Engineering Operations
Building Addition

Contract: 6484
Project: 10308
Common Council Approval:
8/2/2015

Revisions by Addendum

No.	Description	Addendum
1	Re-issued and added notes for clarification	1

13 Pipe, Duct and Column Penetration Flashing
 1 1/2" = 1'-0"

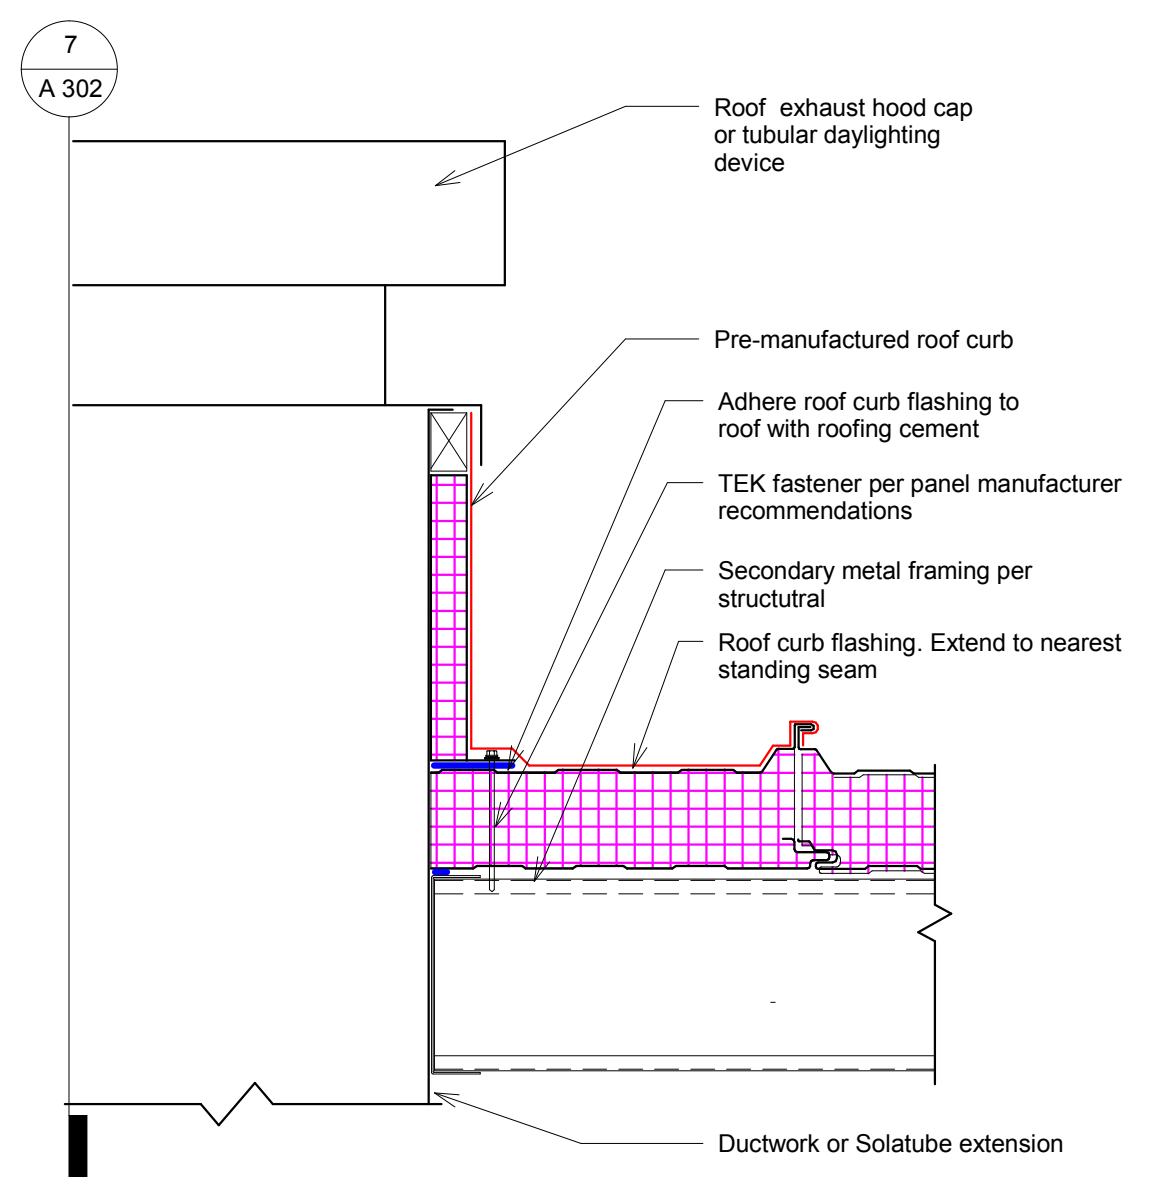
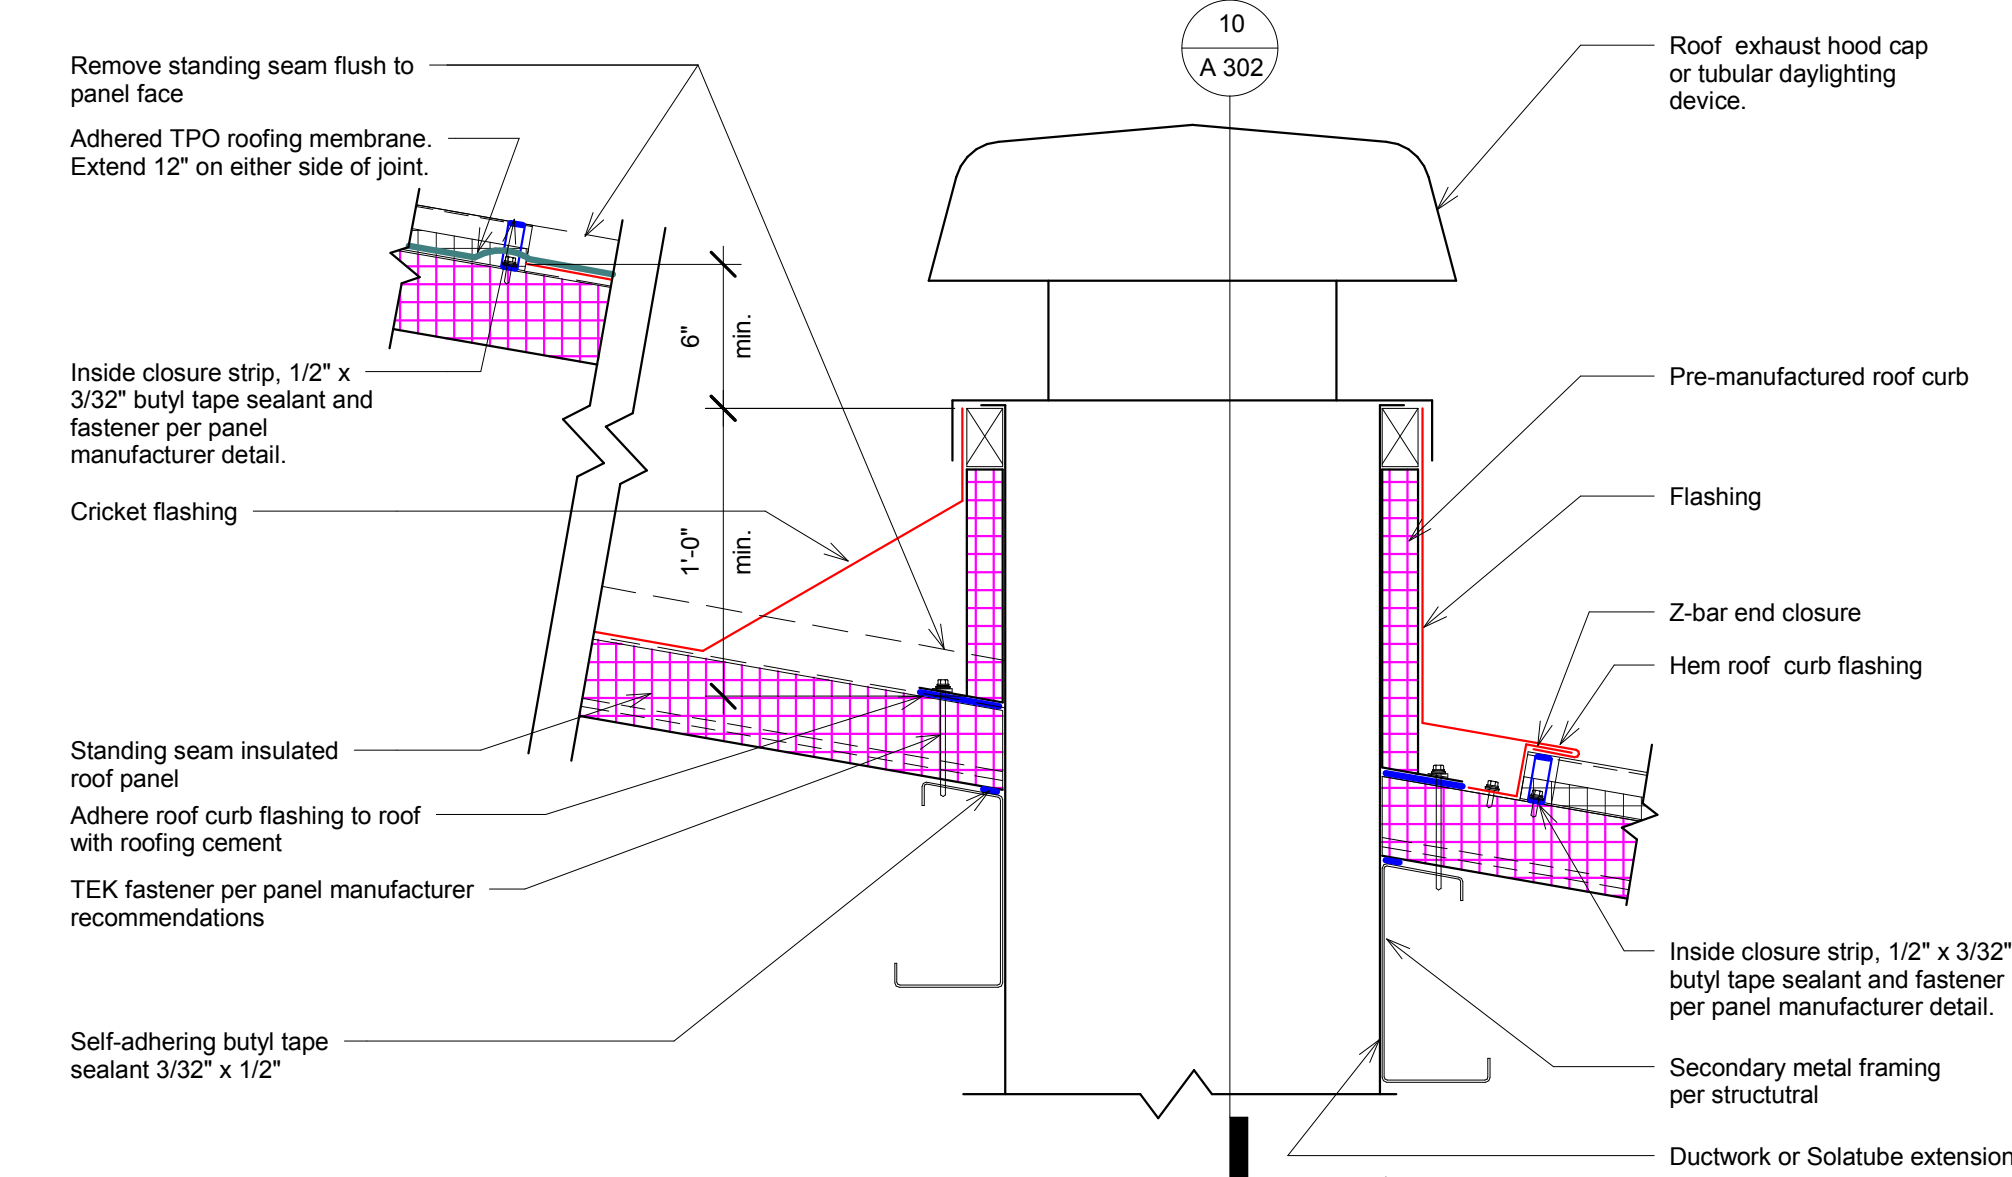
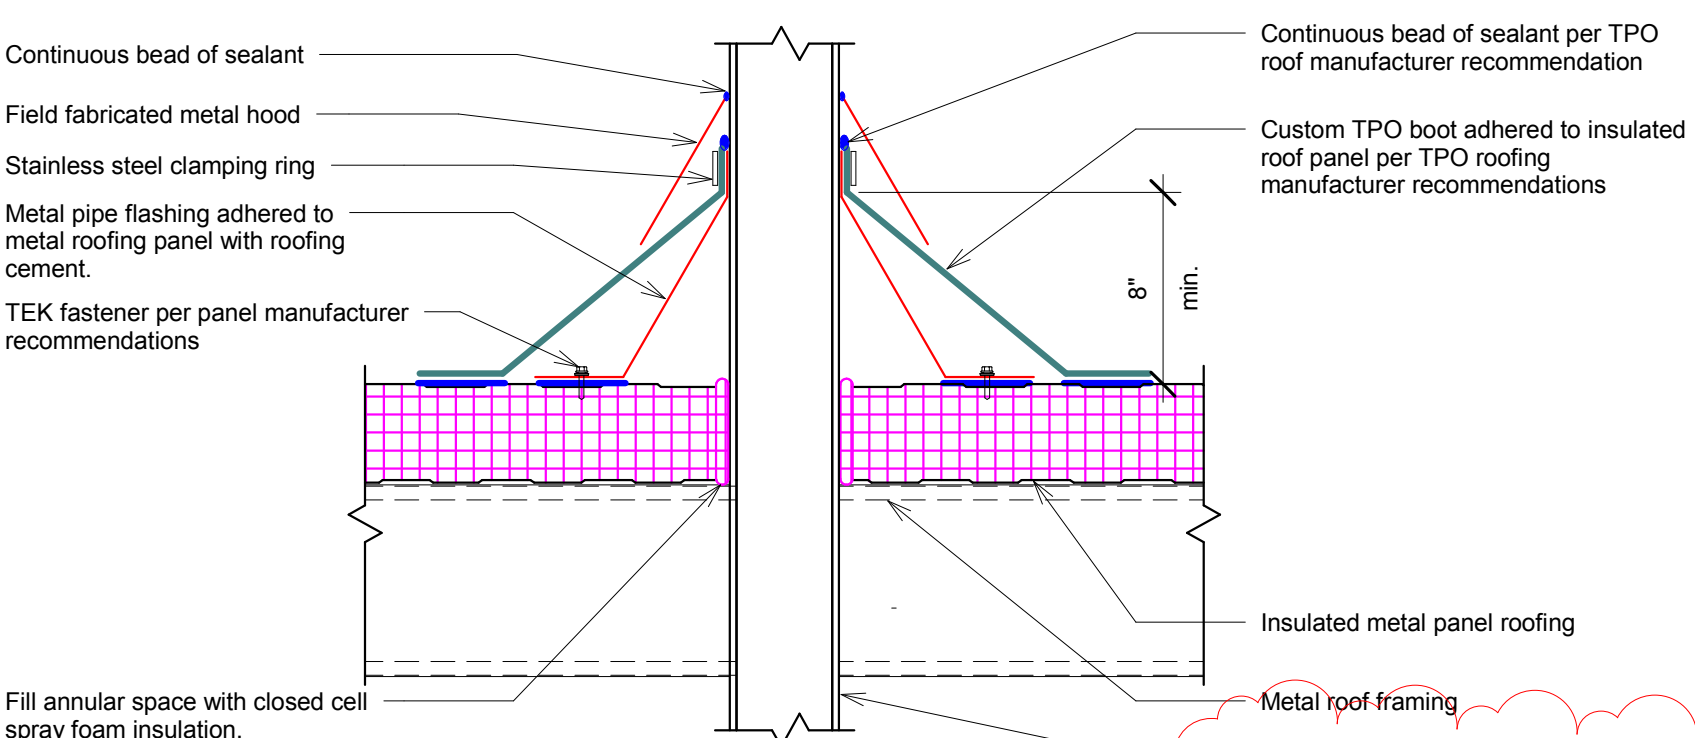
No.	Description	Addendum
1	Detail clarification to include columns and ducts	1

1 Foundation Plan
1/16" = 1'-0"

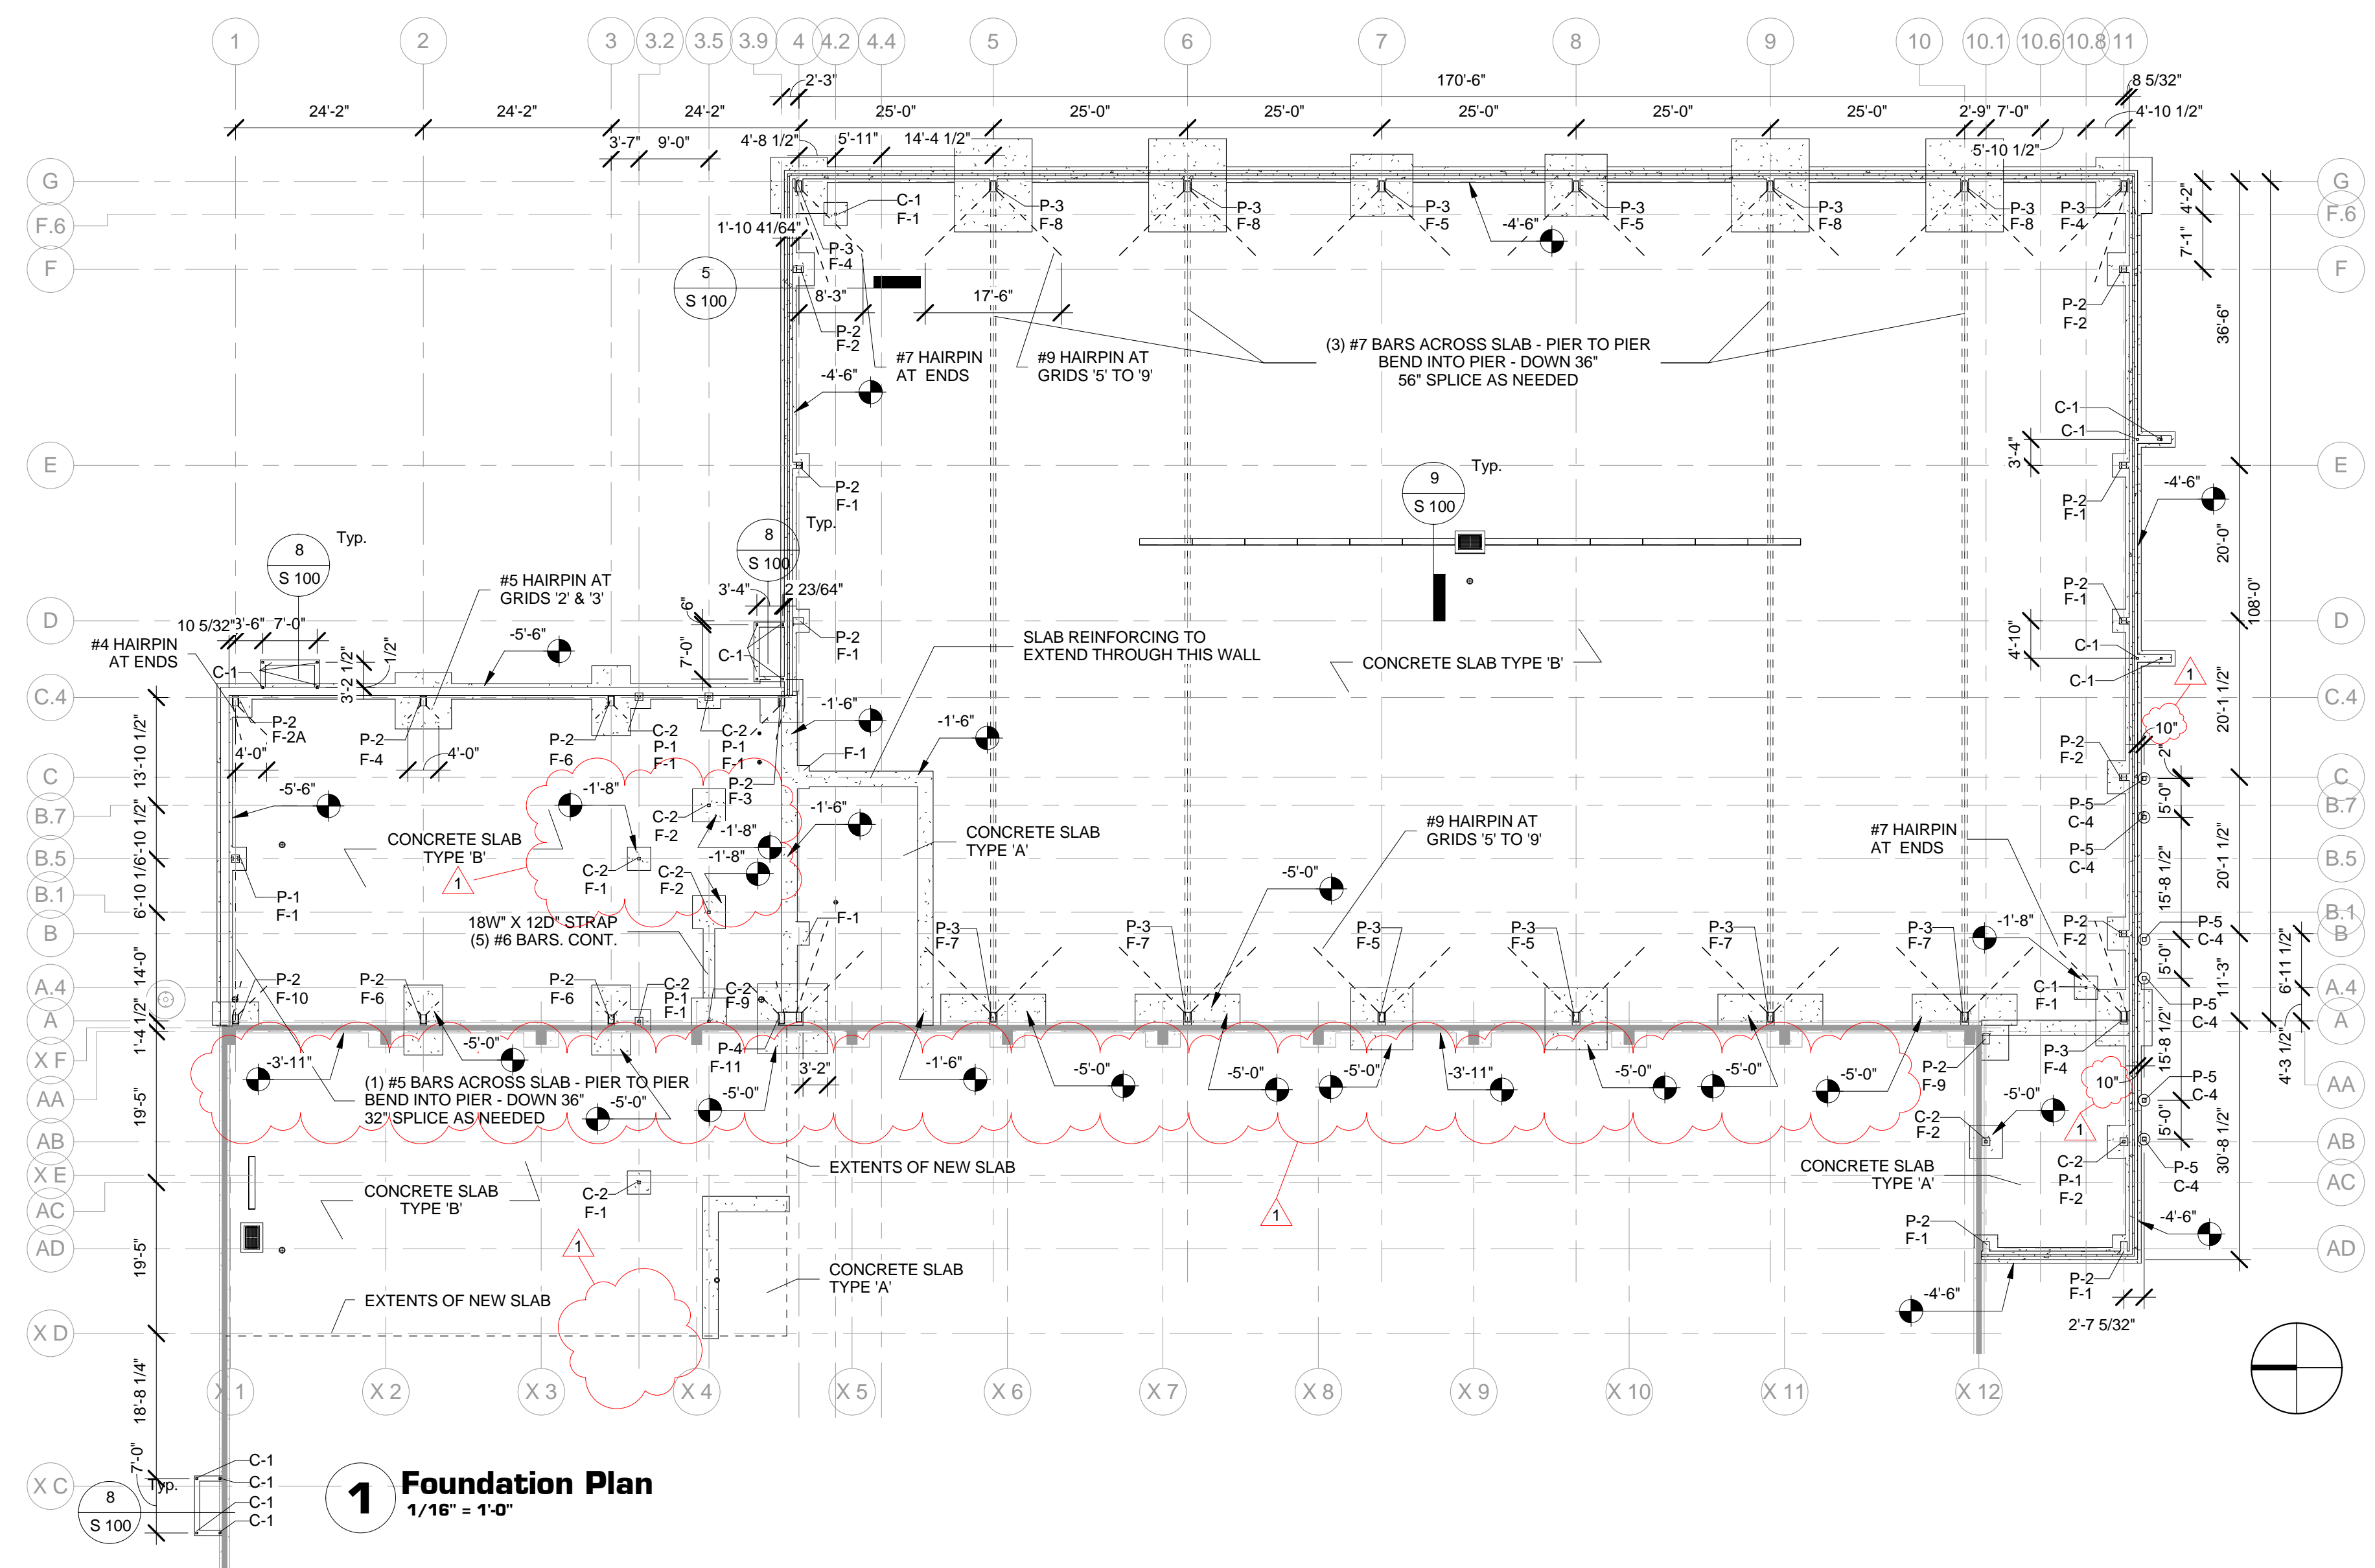
No.	Description	Addendum
1	Foundation plan changes	1
